TECHNICAL BULLETIN
TOOWOOMBA IRON HUB- DISC ROTOR
REPLACEMENT
LIT NO: 97117-254
DATE: August 2015 REVISION: A

Introduction

Hub Rotor Replacement

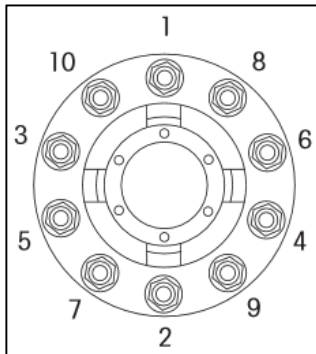
7. Connection of hub to rotor.
 - a. Torque the hub to rotor in star sequence as follows with an initial torque of **100 Nm (70 ft-lb)** and then final torque of **300 Nm (220 ft-lb)**.

Figure 1

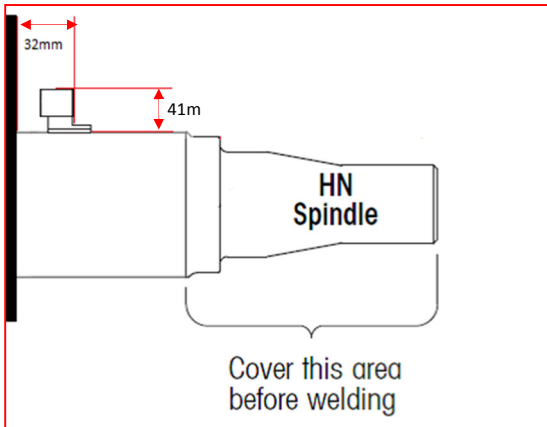
9. The following actions cover the replacement of the ABS sensor bracket.
 - a. Remove the existing ABS bracket.
 - b. Predetermine the approximate location for the new bracket; refer to Figure 1 and 2.
 - c. Prepare the mating surfaces for welding. The mounting area on the axle and the ABS bracket must be free of moisture, dirt, scale, paint and grease.
 - d. The axle and the ABS bracket must also have a minimum temperature of 60°F (16°C).
 - e. Position the ABS bracket along the length of the axle, measure forward (outboard) from the brake caliper torque plate to the outer face of the ABS bracket a distance of 32mm, refer to figure 1.
 - f. Adjust the ABS bracket height by bending both legs symmetrically to achieve a height of 41mm, refer to figure 1.

Figure 2

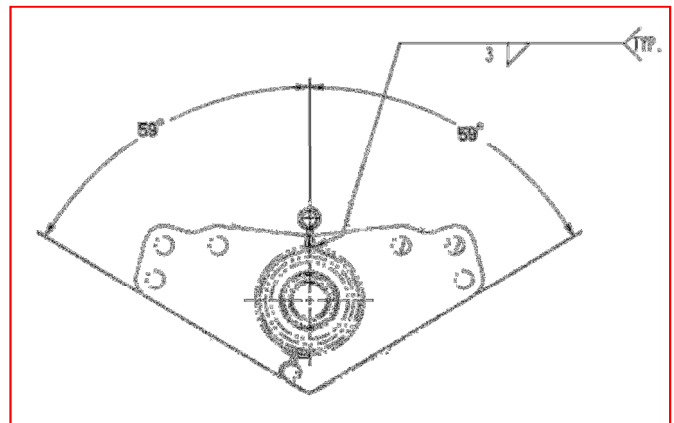
- g. Position the ABS bracket around the outside diameter of the axle and align the centre of the ABS bracket hole with the centre of the slot in the Torque plate, refer to figure 2.
- h. Temporarily clamp the bracket in place. Make sure the ABS bracket is flat against the axle and aligned correctly. The ABS bracket must not be tilted or askew.
- i. Verify that the ABS bracket is in the correct location.
- j. Insert an ABS sensor into the bracket to ensure adequate contact with the pulse ring on the rotor.
- k. When the ABS bracket location and the sensor contact area are verified, weld the ABS bracket to the axle with a 3 mm fillet weld, Refer to figure 3 for weld placement.
